Monthly Specification Update

Intel® Server Board S3420GP

Intel Order Number E82362-009

December 2011

Figure 1. HDD Incompatible Status

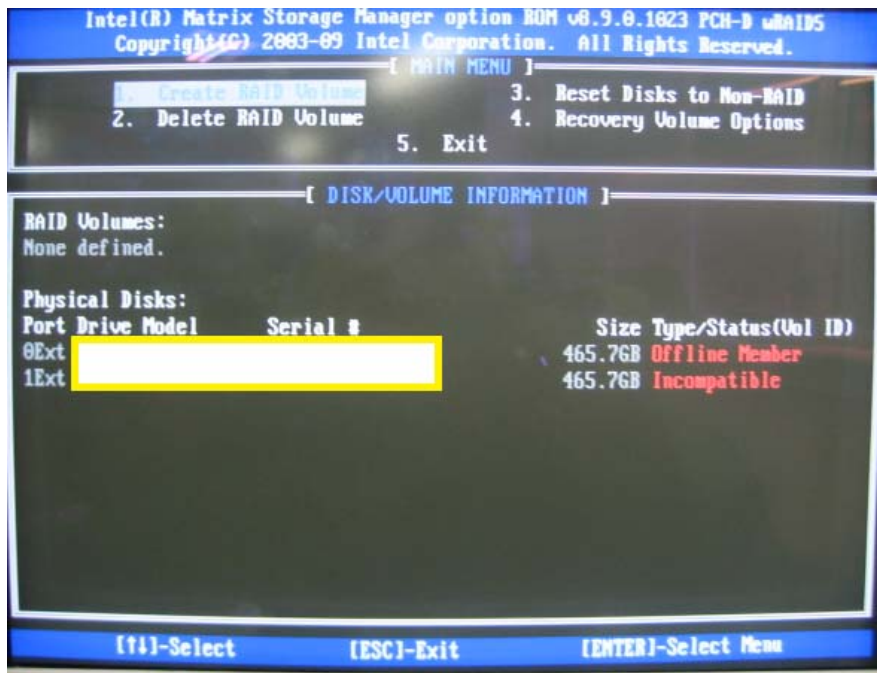
21. Intel® Matrix Storage Manager of Intel® Rapid Storage Technology (Intel® RST) may show HDD incompatible status under certain conditions

Problem	Under RAID 1 mode, if the operating system does reboot after one HDD is unplugged, the other HDD will show incompatible status even after the other HDD is plugged in again.
Implication	Please refer to the picture below.

Status	This issue was fixed in BIOS version 0048.
Workaround	Downgrade BIOS to version 0042 when the issue is happening.

Figure 2. Post Change Installation Procedure

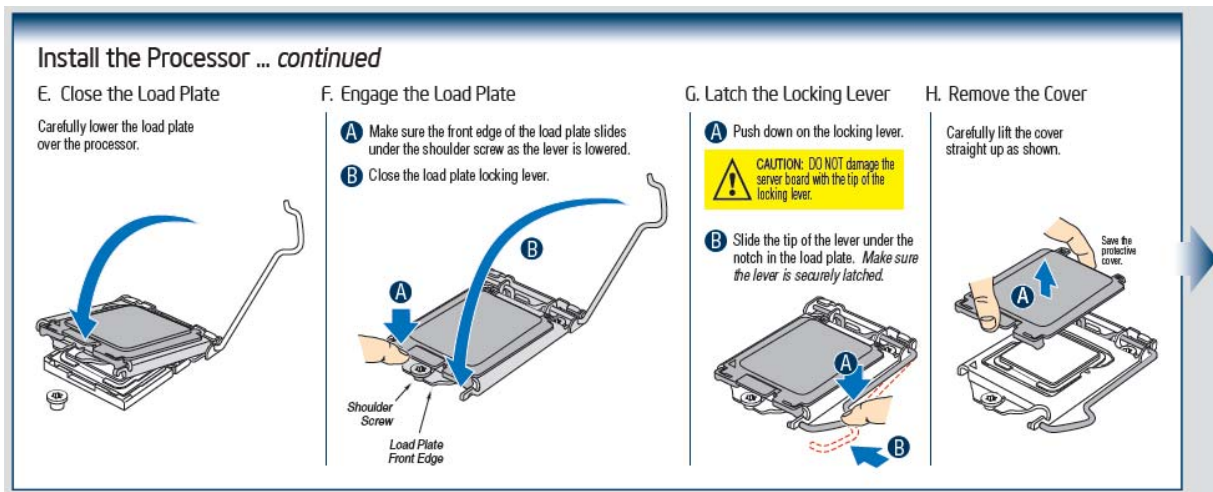
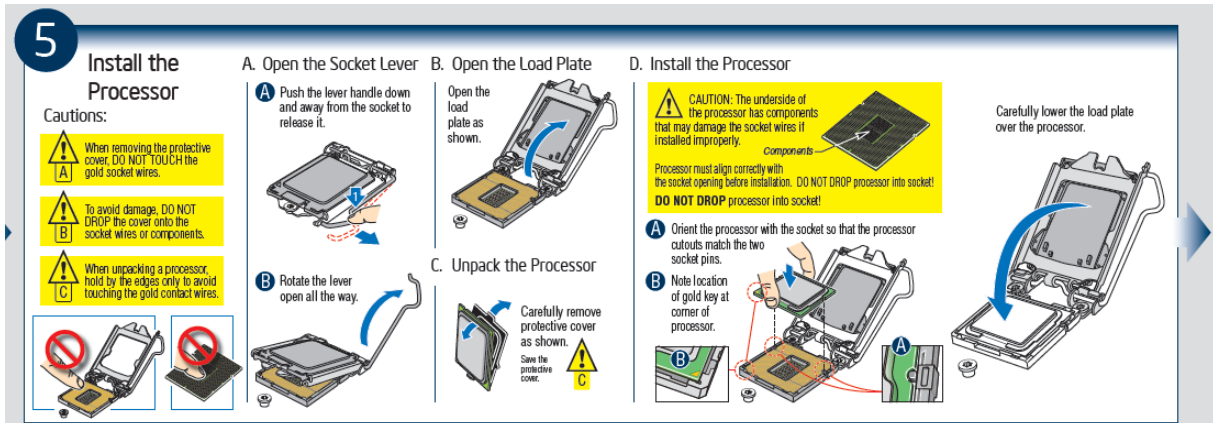
6. Intel® Server Board S3420GP Quick Start User Guide update for the processor socket protective cover change

Implication To reflect the processor socket protective cover change, the following step will be the post-change installation procedure.
